NATURE OF REVISION R-22

PERMIT AND VICINITY MAP
OAK GROVE RESOURCES, LLC
CONCORD PREPARATION PLANT
REVISION R-22 / P-3233
SECTIONS 21, 22, 23, 24, 26, 27, 28, 29, 30 & 34
TOWNSHIP 18 SOUTH, RANGE 5 WEST
SECTION 25, TOWNSHIP 18 SOUTH, RANGE 6 WEST
JEFFERSON COUNTY, ALABAMA
SHEET 2 OF 2

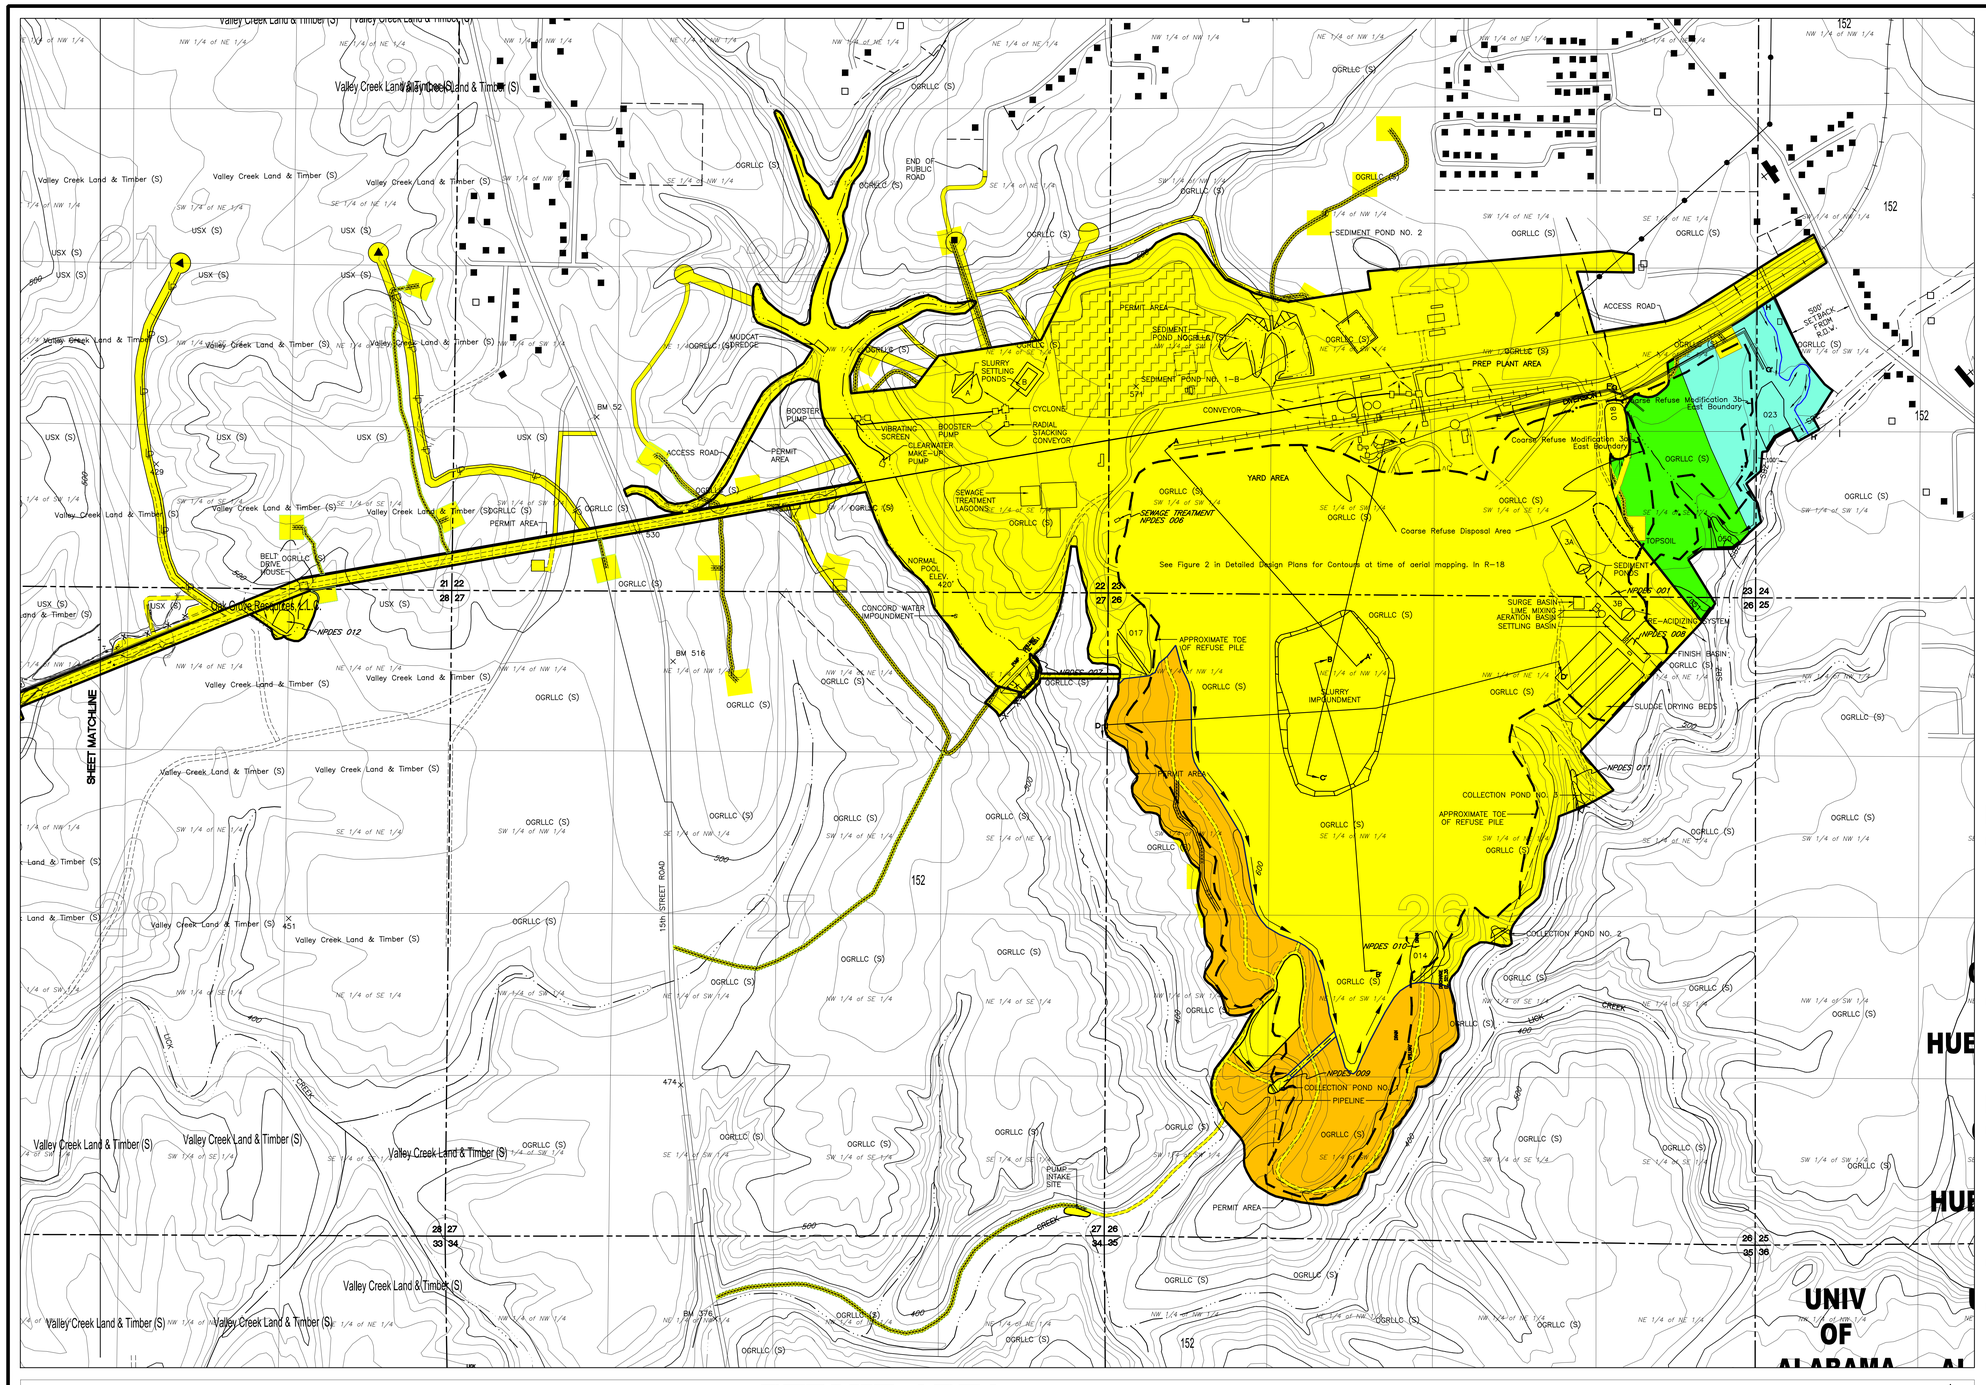
– Add 25 Acres to Increment No.1 for Coarse Refuse Disposal Area Expansion 3a, Basins 050 & 051 Construction, Diversion 1 Construction, Borrow pit and Cover Material Stockpiles.
– Create Increment No.3 for the construction of Basin 023, Diversions G–G' & Bypass Diversion H–H'. Cover Material will be excavated West of Bypass Diversion H–H' and stockpiled within the Permit Boundary & the Watershed of a certified Basin West of Bypass Diversion H–H' and Coarse Refuse Disposal Area Modification 3b.
– Request to update the Operations Plan to include a Modification to the Coarse Refuse Disposal Area Plan.
– Submit the Detailed Design Plans for the modification of the Coarse Refuse Disposal Area 3a.
– Request to update the Drainage Control Plan by adding Diversion Ditch 1, Diversion Ditch G–G', Bypass Diversion H–H', Basin 023 Basin 050 and Basin 051.
– Submit Detailed Design Plans for Basin 050, Basin 051 and Diversion Ditch 1.

– Submit Detailed Design Plans for Basin 023, Diversion Ditch G–G', Bypass Diversion H–H' and Coarse Refuse Disposal Area Modification 3b prior to Bonding of Increment No. 3.
– Delete Basin 018 upon construction and certification of Basin 051 to the Regulatory Authority.
– Update the Ownership on the Permit Map and in Part I.
